NOTICE OF ADDENDUM
 ADDENDUM NO. 1
 CONTRACT NO. 7430

NORTH LAKE STREET RESURFACING -
 ASSESSMENT DISTRICT 2016

Sheet U-1: Modified 14" lateral at SAS #1.

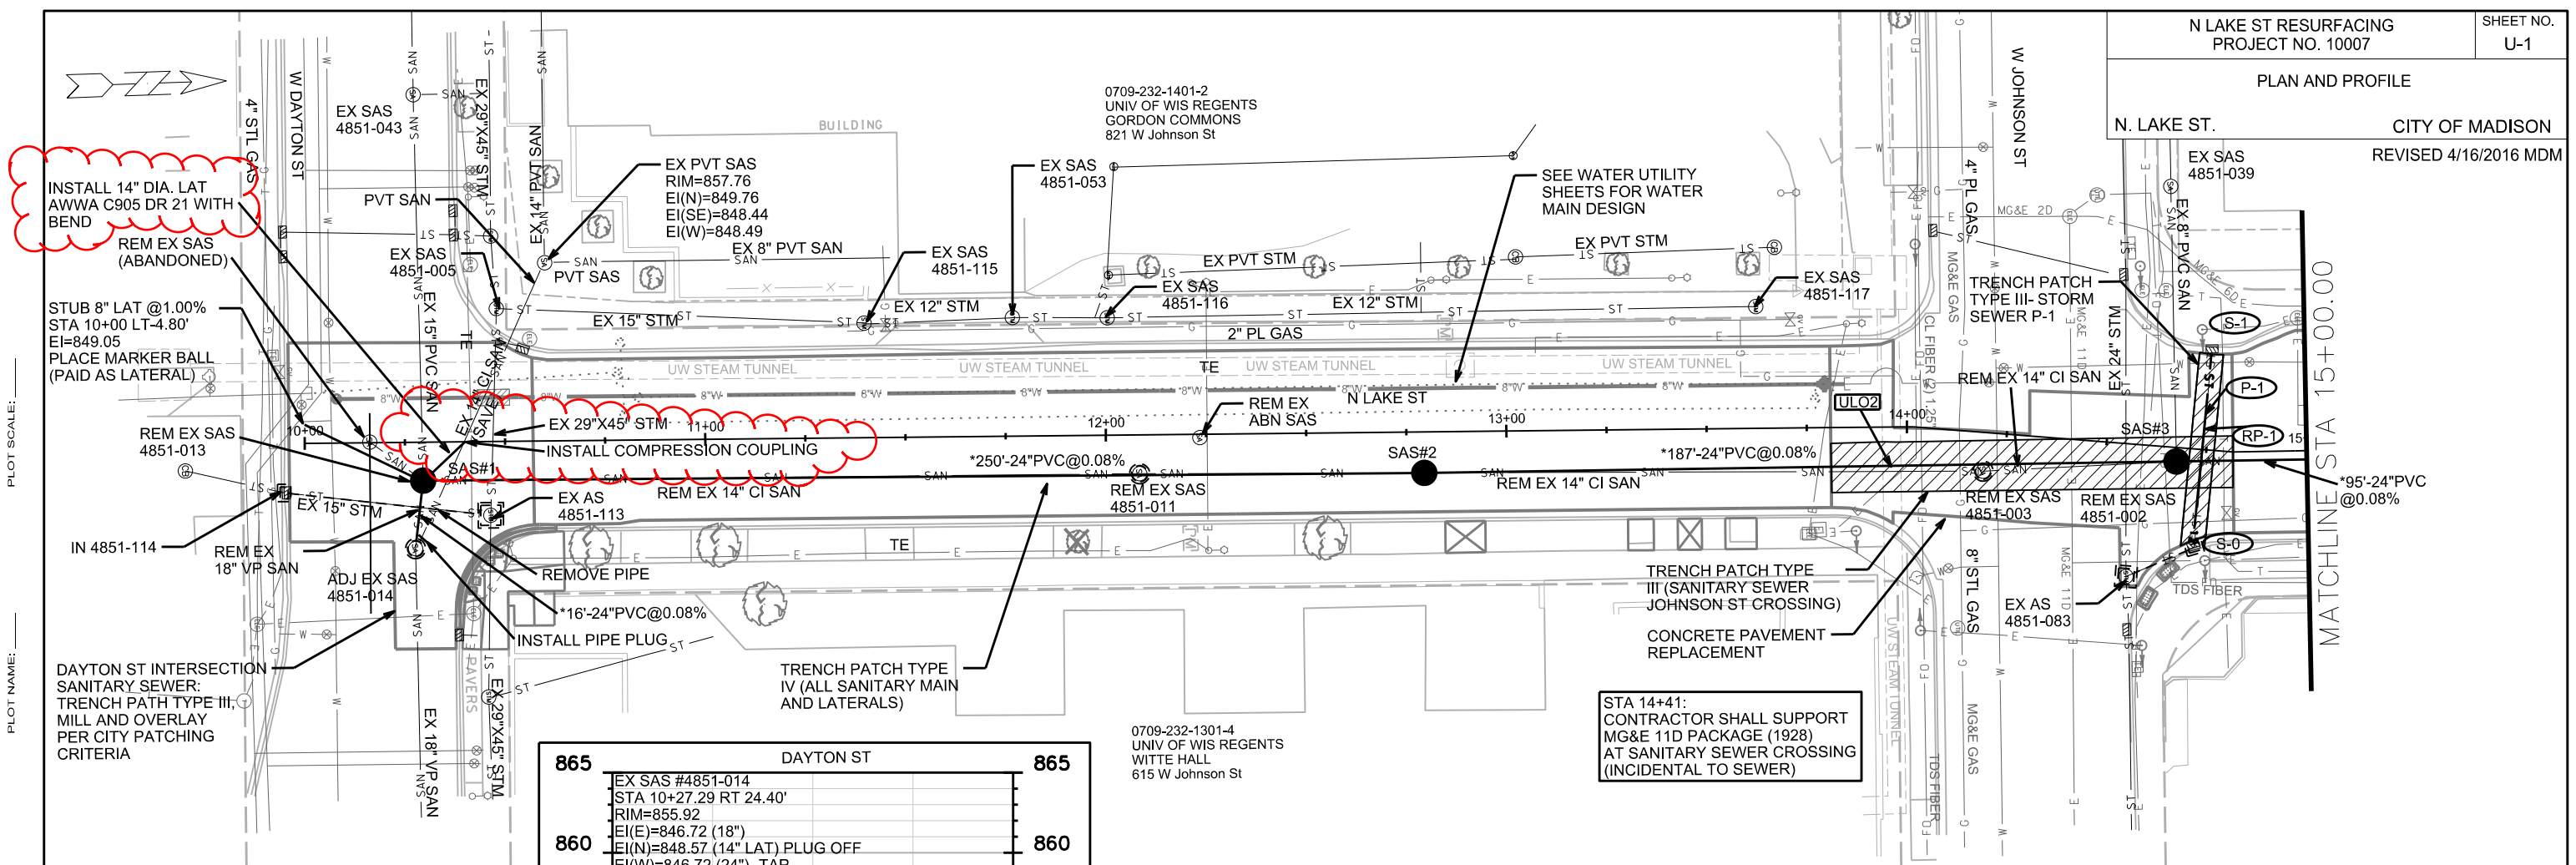
INSTALL 14" DIA. LAT
AWWA C905 DR 21 WITH
BEND
REM EX SAS
(ABANDONED)

REMOVE PIPE

INSTALL PIPE PLUG

Work under this bid item shall include installation on 14" diameter sewer lateral as shown on the plan set. The 14" diameter pipe installed shall be 14" diameter AWWA C905 DR 21. The 14" diameter sewer lateral is located on the plans according to survey and the UW utility records. The AWWA C905 pipe was not selected because of needing to be pressure rated (this not an encroachment to water main) but rather it was select to attempt to best match the size of the existing 14" diameter cast iron pipe. If the contractor determines that that the inside diameter of the C905 pipe is smaller than the cast iron pipe, the contractor shall propose an alternate pipe at not no additional cost.

The bend necessary to connect the 14" diameter lateral to the existing 14" diameter cast iron sewer shall be considered incidental to the sanitary sewer lateral.

The old 14" diameter cast iron lateral shall be removed and also plugged off at SAS 4851-014. Pipe plug necessary to abandon the old cast iron pipe shall be paid for separately under Bid Item 20336 Pipe Plug. Pipe Removal shall be paid for under Bid Item 20314 – Remove Pipe.
